Re: *E210059 (Lunenburg, VT)*

This letter is in response to requests from the Federal Communication Commission to provide supplemental information with regard to the earth station application referenced above. Specifically, the Commission requested the following information:

Figure 1: PFD Contour with county boundaries and distance/mileage scale

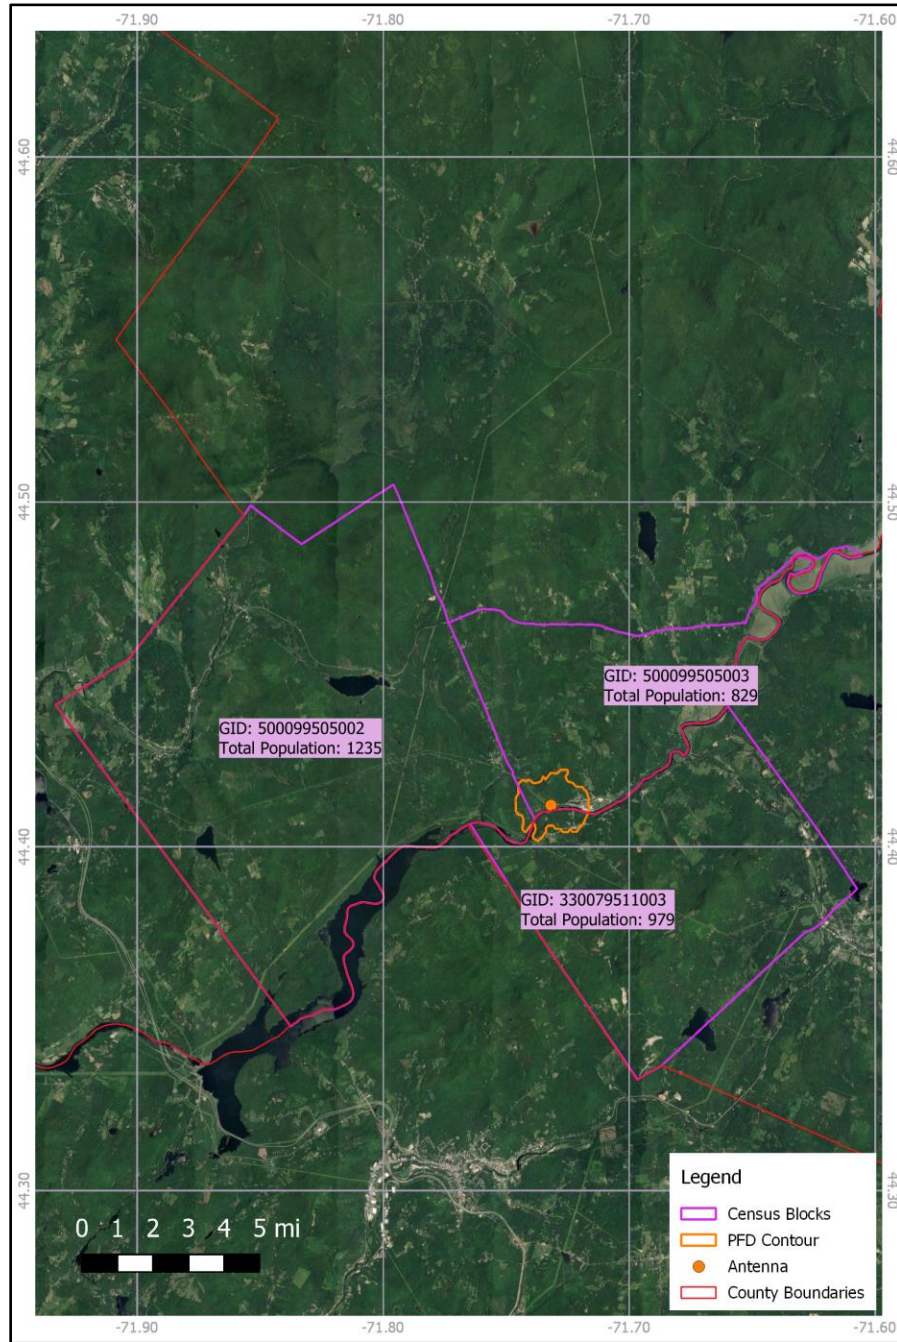
1) Addition of county boundaries and distance/mileage scale to PFD contour plots

In accordance with 47 CFR § 25.136(a)(4)(ii) and 47 CFR § 25.136(a)(4)(iii) county boundaries and map legends with distance/mileage scale for measuring the relative size of the proposed PFD contour are included as Figures 1-3 in the appendix of this document

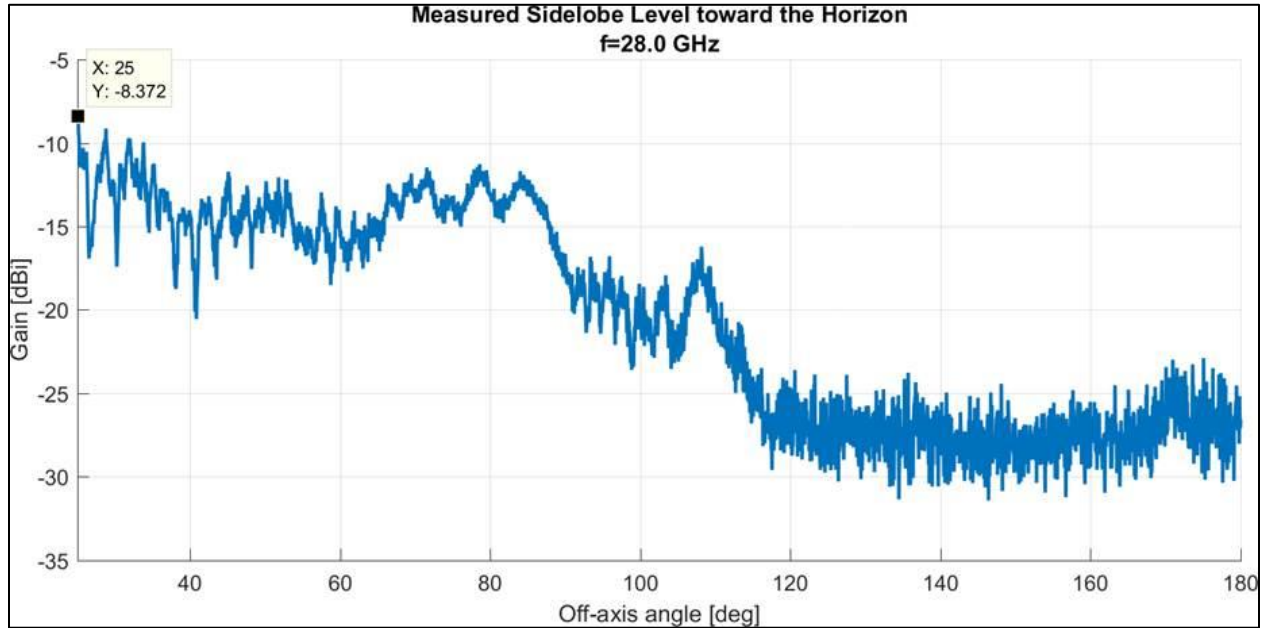
6) Explanation of changes in antenna sidelobe levels

There have been changes over time in the antenna sidelobe level toward the horizon used in SpaceX’s earth station applications. The changes are due to improvements in SpaceX earth station antenna design over time – newer antennas have a lower antenna sidelobe level toward the horizon.

While previous applications may feature an antenna sidelobe level towards the horizon of -1 dBi or -3 dBi, this application features an antenna sidelobe level towards the horizon of -8 dBi.

For the reasons explained above, an antenna sidelobe level towards the horizon of -8 dBi is a more accurate representations of reality for this earth station than values of -1 dBi or -3 dBi that may have been used in previous applications. See appendix Figure 4 for detail on antenna sidelobe measurements and related methodology.

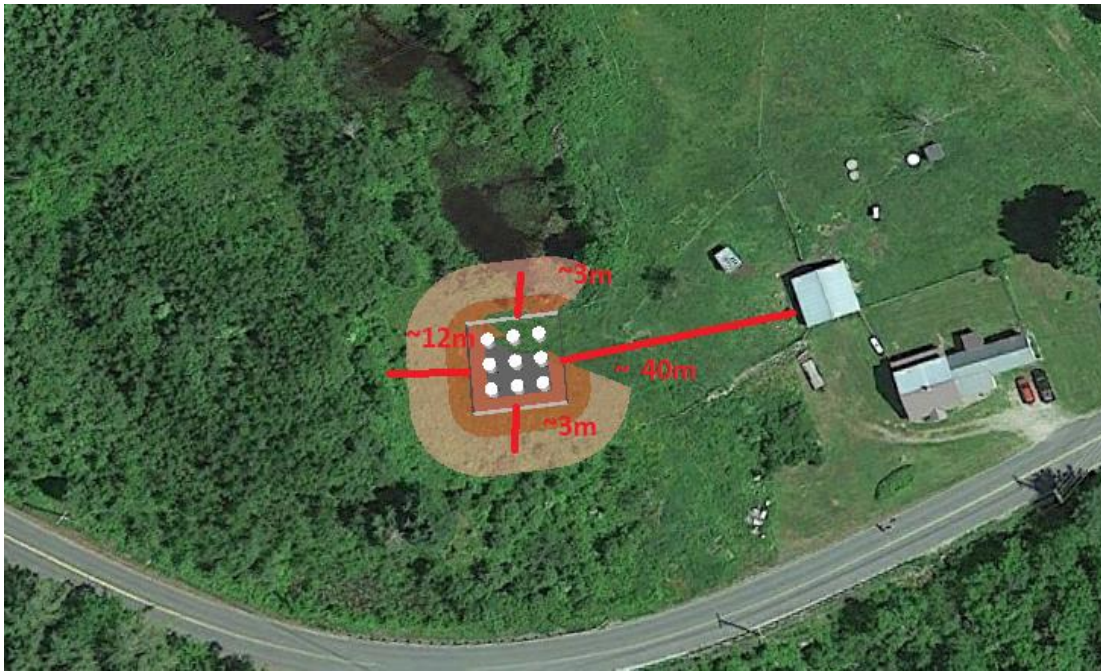
7) Explanation of clutter assumptions

The “irregularly spaced sparse trees” and “sparse houses” clutter categories of the ITU P.452 model were used for this application. According to the ITU P.452 model, this translates to clutter assumptions of 4 meters nominal height and 0.1 kilometers nominal distance.

The “irregularly spaced sparse trees” and “sparse houses” clutter categories were determined to be most appropriate based on measurements and analysis via Google Earth software and in-person site survey. Figures 5-6 provide a visual of the site environment, obtained via Google Earth software and in-person site survey.
